Historical Architectural Review Board

COA Preliminary Review Sheet

HDC-2025-00091

Address: 231 N Fulton Street

Current condition (Applicant)

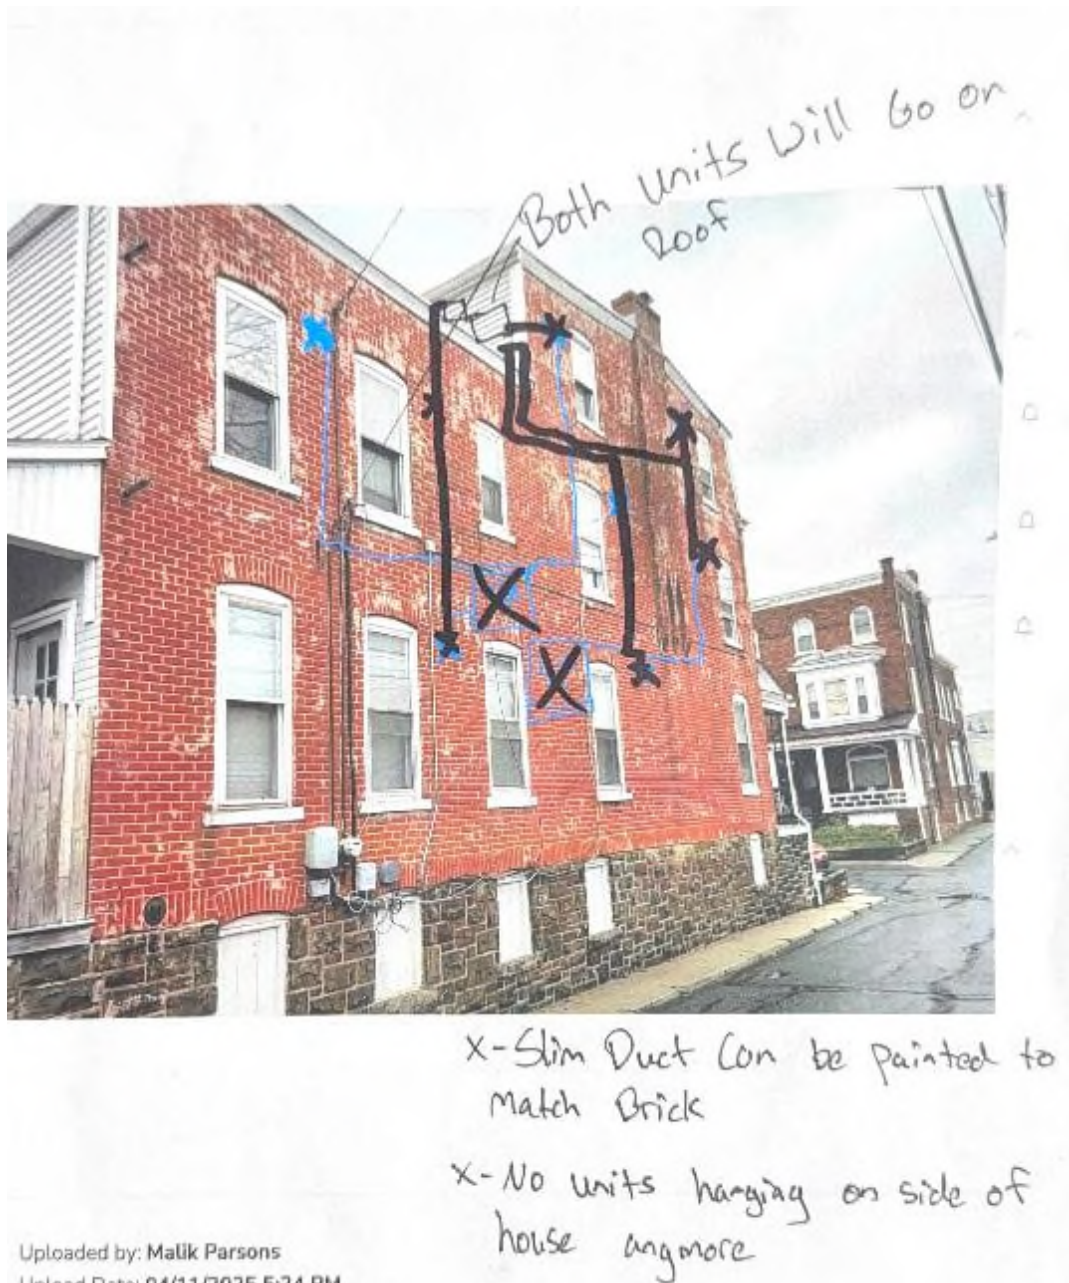
Observations & Comments: This application follows the denial of the legalization of the mini-split installation at the October 6, 2025, HARB meeting. The current HVAC system is installed on the exterior wall of a corner building, along Emmett Street. Two units are mounted on the wall near the top of first floor windows and various equipment lines are routed across the wall surface.

The current Slimduct lines are white and highly visible on the exterior. The applicant's proposal to paint the Slimduct to match the exterior brick is appropriate to make these elements more inconspicuous and blend in. The proposed work includes brick repair. More information would be helpful to understand the intent, location, and materials used in brick repair.

- The roof-mounted mechanical units are set back from the roof edge so that they are not visible from a public right-of-way.
- Brick repair is performed so that any units and mortar match the existing in dimension, materiality, texture, pattern, and color.

- The roof-mounted mechanical units are set back from the roof edge so that they are not visible from a public right-of-way; minimum 5'

- Brick repair is performed so that any units and mortar match the existing in dimension, materiality, texture, pattern, and color. This would be sent to staff for approval.
- As demonstrated in submitted photos and in discussion, all Slimduct lines would be routed vertically to avoid major horizontal runs.
